**SERVICE DIRECTIVE BULLETIN**

SERVICE DIRECTIVE BULLETIN NO. 0110

Revision 4

1. SUBJECT: Cyclic Trim System – Cyclic Trim Assembly Kit for the Lateral and Longitudinal Trim Actuator Assemblies
2. MODEL: All F-28F, 280F, and 280FX models equipped with 24 volt D.C. system;  
Any F-28F model equipped with a 12 volt D.C. system with trim relays (S/N 815 only);  
Any F-28C, F-28C-2, or 280C models that have been converted to a 24 volt D.C. system+
3. EFFECTIVITY: F-28F Series: Serial Numbers 828 and prior  
280FX Series: Serial Numbers 2133 and prior
4. REFERENCE: Enstrom F-28A/F-28C Series Maintenance Manual, Latest Revision  
Enstrom 280/280C Series Maintenance Manual, Latest Revision  
Enstrom F-28F/280FX Series Maintenance Manual, Latest Revision

Figure 1: Trim Relay (M83536/10-024M Relay Shown)

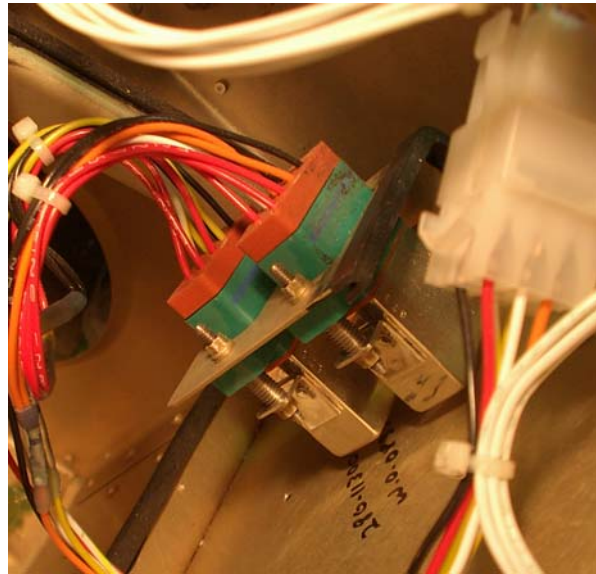
This condition can only occur on aircraft equipped with P/N KUP14D55-24, KUP14D55-472, M83536/10-015M, or M83536/10-024M trim relays (Figure 1). Aircraft equipped with solid state trim switch units P/N 4199059-1 or 4192102-( ) (Figure 2) are not at risk because those units do not have a failure mode that could cause a runaway. Aircraft equipped with a reversible trim motor, P/N 28-16621 (Ford Motor Co. C1AZ-14553A) or P/N AD1R-10 (Signal Electric), are not at risk because the trim system does not use relays or solid state trim switch units. NOTE: If the electric motor on the trim actuator has three wires, it is not affected. All motors in systems with relays or solid state trim switch units have only two wires.

Compliance with this SDB must be completed within the next 5 hours or at the next annual or 100 hour inspection, whichever occurs first, for aircraft equipped with P/N KUP14D55-24, KUP14D55-472, M83536/10-015M, or M83536/10-024M trim relays. See Figure 1 for a pictorial example of a relay. Note: This includes aircraft modified per SIL 0164.

Figure 3: Maximum Stroke Limit at 1.95"

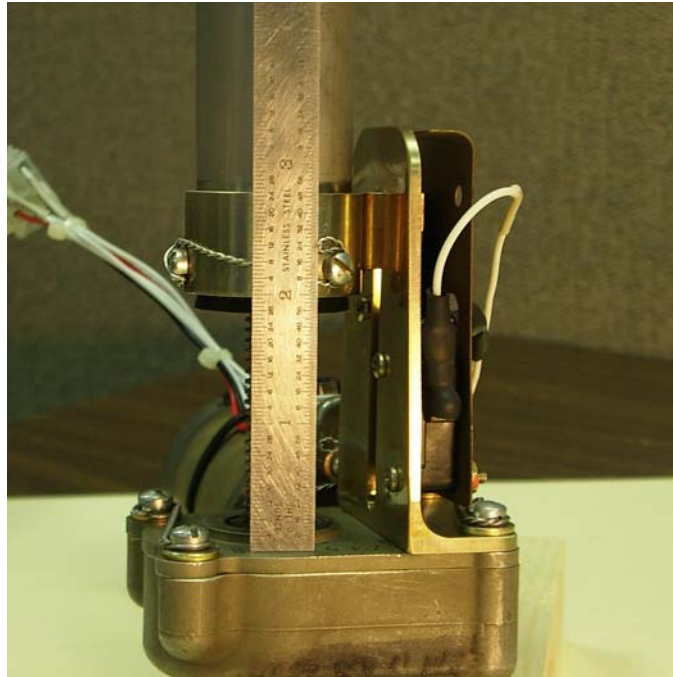
- L. Apply power to the trim actuator assembly to check and adjust the travel of the spring housing.
  1. Install the electrical connectors.
  2. Both trim actuator assemblies can be electrically tested from either the left or right hand side of the aircraft, whichever location is more convenient. Set the trim actuator assembly on a portable bench or suitable stable surface to perform the check and adjustments.
- M. Check the spring housing travel and adjust the switch positions to ensure that the retracted and extended spring housing travel are within the limits specified on the drawing or as determined in the note below. Enlist a second person to assist with the cyclic operation while conducting measurements and adjustments (Figure 3).

**The retracted travel or minimum stroke limit is 0.125" +0.075"/-0.00". The extended travel or maximum stroke limit is 1.95" +0.00"/-0.05".**

Figure 4: Trim Actuator Assembly (Lateral Trim Actuator Retracted)

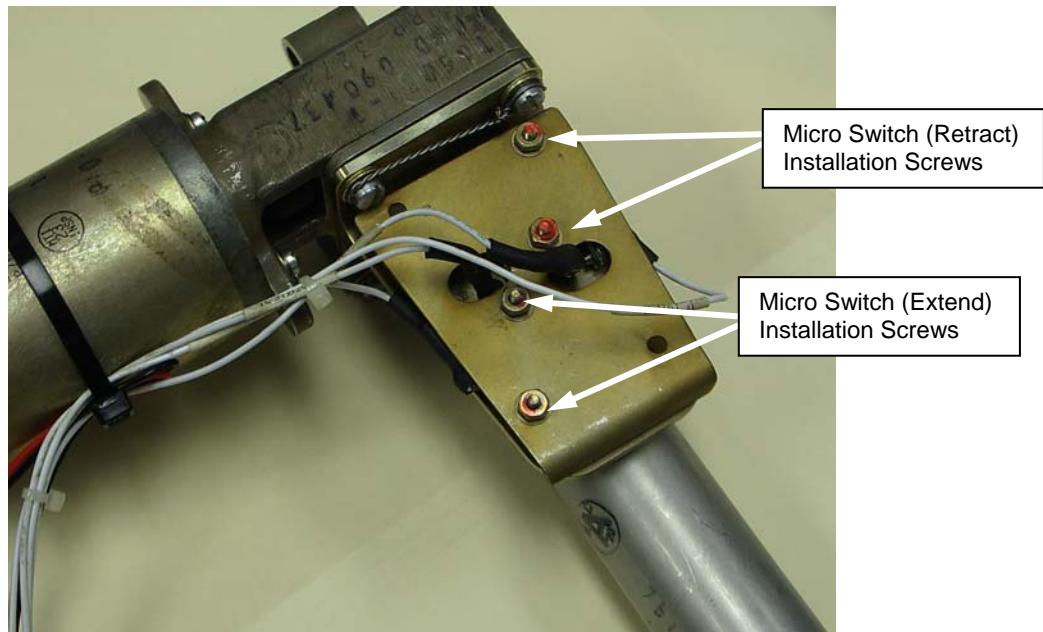
1. To adjust the spring housing travel, loosen the switch mounting hardware to set the switch position(s) as necessary to bring the spring housing travel within limits. For example, to shorten the spring housing extension, loosen the switch mounting hardware for the extending switch and adjust the switch position inward (Figure 4).
2. Check spring housing travel to verify that proper adjustment was made.

**If is not possible to achieve the limits after adjusting the switch positions, either the bracket slot or the switch screw slots may be filed to achieve the travel limits. The maximum amount that the bracket slot may be filed is 0.040”.**
